Exhibit A

Recommended Amendments to the 2018 International Building Code City of Amarillo, Texas

FIGURE 1511.3.1.1 HAIL EXPOSURE MAP

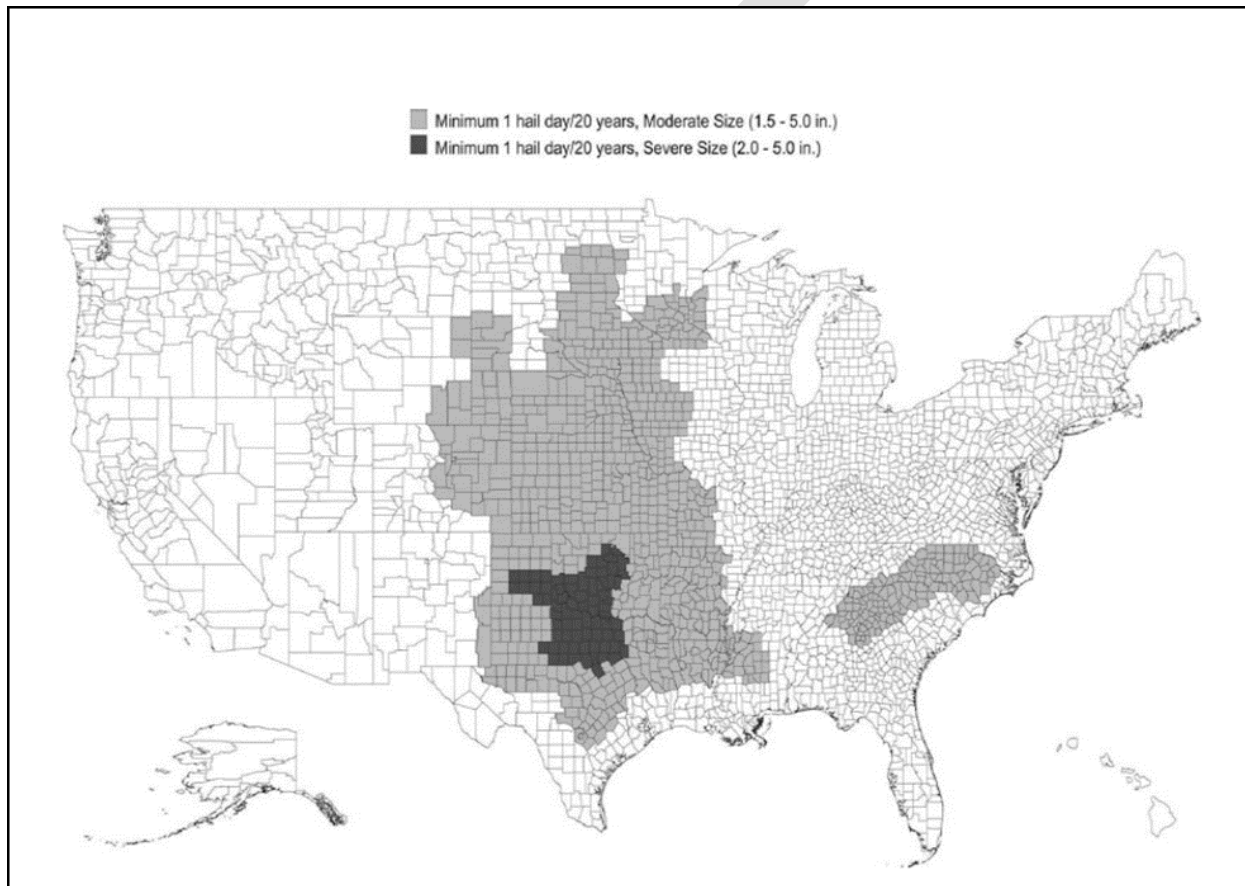
****Section 1511.3.1.1; insert Figure 1511.3.1.1; change to read as follows:**

1. Where the existing roof or roof covering is water-soaked or has deteriorated to the point that the existing roof or roof covering is not adequate as a base for additional roofing.
2. Where the existing roof covering is wood shake, slate, clay, cement or asbestos-cement tile.
3. Where the existing roof has two or more applications of any type of roof covering.
4. For asphalt shingles, when the building is located in an area subject to moderate or severe hail exposure according to Figure 1511.3.1.1.

(Reason: Due to the of weather in the Panhandle, wind and hail damage is more prone when asphalt shingles used for re-covering; contractors unable to verify if any of the decking may need to be replaced and unable to verify the flashing integrity)

*****Figure R602.6.1; delete the figure and insert the following figure:**

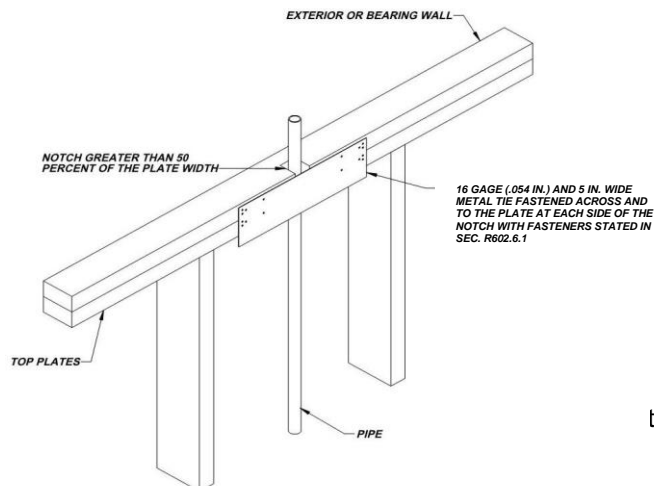
R602.6.1 Drilling and notching of top plate. When piping or ductwork is placed in or partly in an exterior wall or interior load-bearing wall, necessitating cutting, drilling or notching of the top plate by more than 50 percent of its width, a galvanized metal tie not less than 0.054 inch thick (1.37 mm) (16 Ga) and 4½ inches (38) mm 5 inches (127 mm) wide shall be fastened across and to the plate at each side of the opening with not less than eight 10d (0.148 inch diameter) ~~nails having a minimum length of 1½ inches (38 mm) or eight (#10) wood screws having a minimum length of not less than 1½ inch (38 mm)~~ at each side or equivalent as approved by the Code Official. Fasteners will be offset to prevent splitting of the top plate material. The metal tie must extend a minimum of 6 inches past the opening. See figure R602.6.1. *{Remainder unchanged}*

(Reason: Amendment to provide additional assurance of maintaining the integrity of the framing by spreading the nailing/screw pattern.)
